RE: S/D 99-36 -- One-Step Final Plat of CHENEY BAPTIST CHURCH ADDITION

RE: S/D 99-36 -- One-Step Final Plat of CHENEY BAPTIST CHURCH ADDITION

STAFF REPORT
(One-Step Final Plat Approved 6/03/99)

CASE NUMBER: S/D 99-36 -- CHENEY BAPTIST CHURCH FIRST ADDITION

CHENEY BAPTIST CHURCH 1ST ADDITION TO SEDGWICK COUNTY, KANSAS LOT 1 BLOCK 1

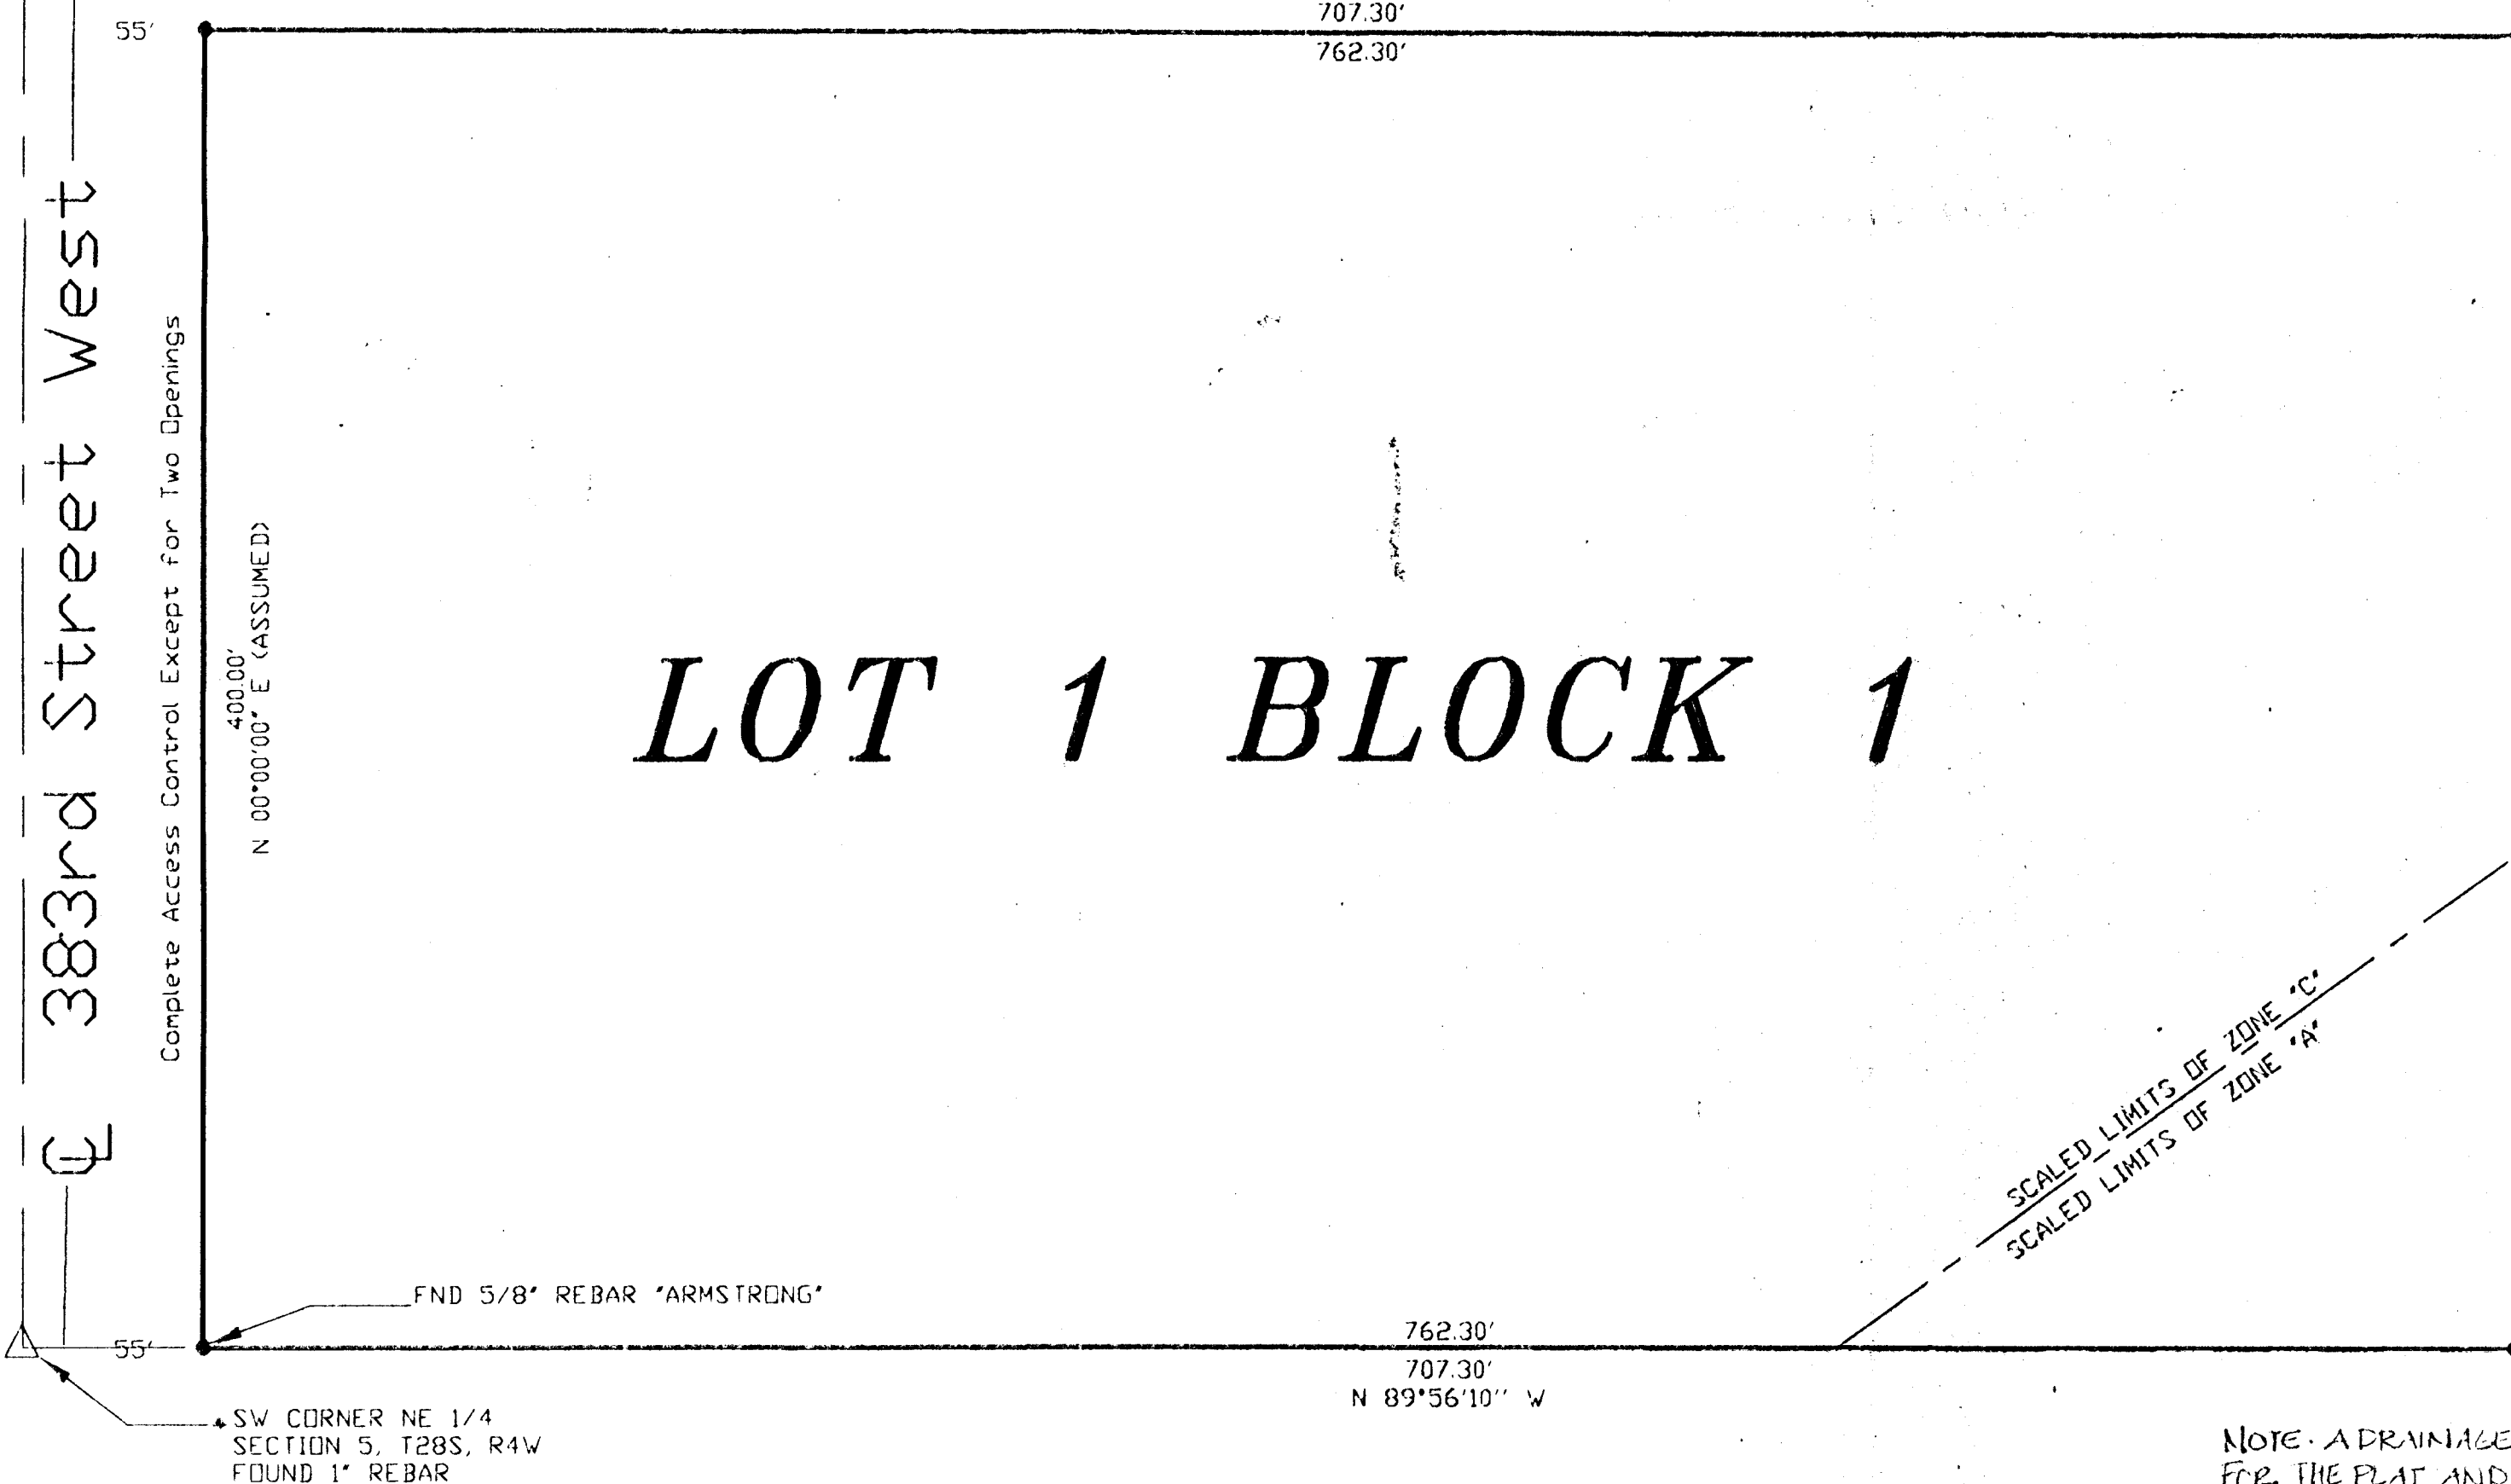
- C. County Engineering needs to comment on the status of the applicant's drainage plan and the need for floodway reserves. The plat's text shall note the creation of any floodway reserves in addition to the standard floodway language. A drainage plan is required before this plat can be considered by the Planning Commission. Flood elevations need to be submitted to determine minimum building pad elevations.

- D. The name of the adjoining street – 383rd St. West – shall be denoted, along with the centerline.
- E. Access control except for two openings shall be dedicated along 383rd St. West and referenced in the plat's text. County Fire has required two access openings - one emergency opening is requested.

- F. The legal description needs to be revised to accurately portray the land being platted. The distance "707.30" should be "762.30".
- G. Since this is not a replat of various public reservations, the platlor's should not make reference to KSA 12-512(b).

- I. The platlor's text shall include language that a drainage plan has been developed for the plat and that all drainage easements, rights-of-way, or reserves shall remain at established grades or as modified with the approval of the applicable City or County Engineer, and unobstructed to allow for the conveyance of stormwater.
